SUPPLEMENTAL INFORMATION #1

Project Title: **Lucas and Myrtle Mini-Storage Center**
Record Number: PLN-2020-16400
Assessor Parcel Numbers: 015-111-006, 015-111-012, 015-111-013
Location: Myrtle town Area

LAND USE DIVISION INTEROFFICE MEMORANDUM

RE: **J & J FAMILY LLC; APN 015-111-006, APPS# PLN-2020-16400-CUP**

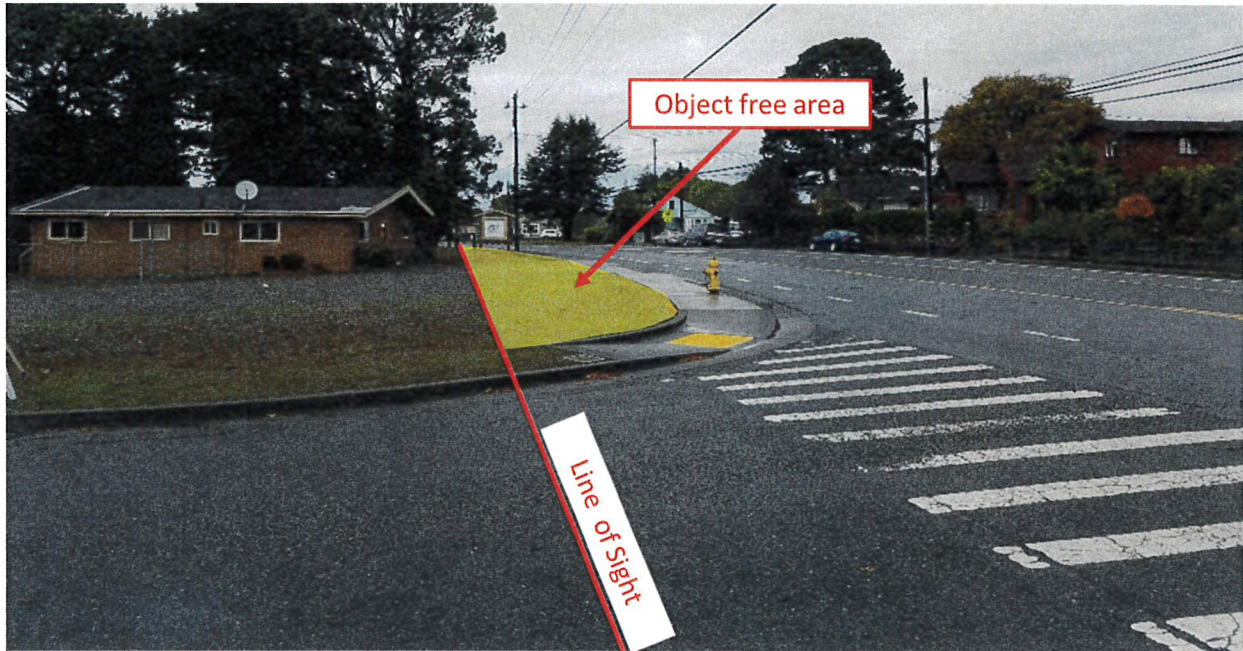
SITE PLAN: The Department has received a site plot plan that does not show and/or dimension existing roadway width, right of way width, and existing pedestrian improvements fronting the parcel.

Because the existing improvements are not shown and dimensioned within the road right of way, the site plan must be revised to correctly show and dimension the road right of way lines, the curb line, pedestrian improvements, proposed and existing commercial driveway locations, and line of sight per Humboldt County Road Design Manual Section 2-341.

Public Works cannot evaluate the project and issue recommended conditions of approval until the site plan has been revised to show this information.

(3) Submit an accurate site plan to the Department of Public Works for Approval prior to project approval. The site plan shall show the County road right of way, existing improvements, and location of any drainage leaving the site. **The Department will issue revised/updated recommended conditions of approval after review of the revised site plan.**

Above: Sight visibility line drawn on photo (approximate)

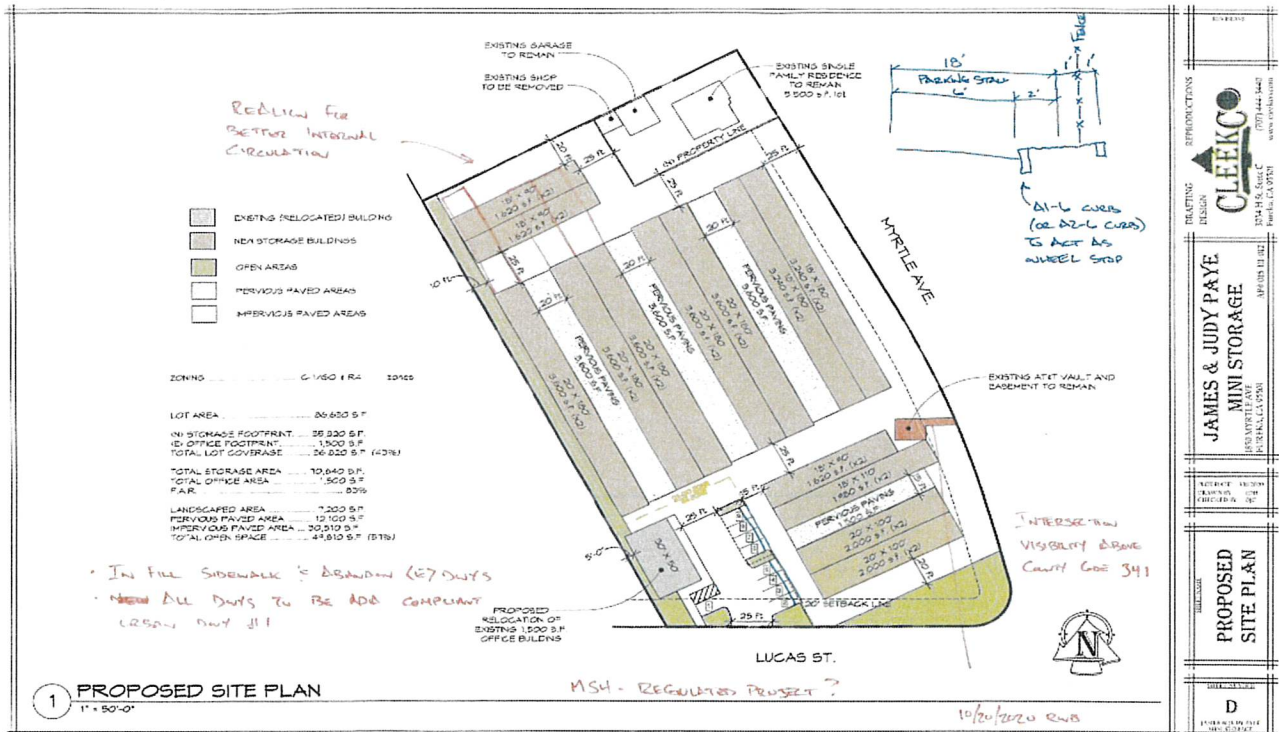
(1) Myrtle Avenue has a posted speed limit of 35 MPH. The subject property and Lucas Street are located on the inside of the curve of Myrtle Avenue. Line of sight is a common issue on the inside of a curve due to development blocking sight lines. Development within the front yard setback of Myrtle Avenue will negatively affect sight distance for Lucas Street traffic at the Myrtle Avenue intersection. Special conditions of visibility maintenance are required per County Code Section 341-1 and Humboldt County Road Design Manual Section 2-341 including a 350 foot line of sight. Prohibiting the development of all structures (including signs and fences) within an approximate 10 foot setback of the right of way line will help preserve the line of sight at this location. Even wrought iron or chain link fencing may be difficult to see through due to the line of sight running almost parallel to the potential placement of fencing at the right of way line. If the applicant is proposing

(11) A Development Plan shall be filed with the Planning & Building Department that shows the visibility clear zone area.
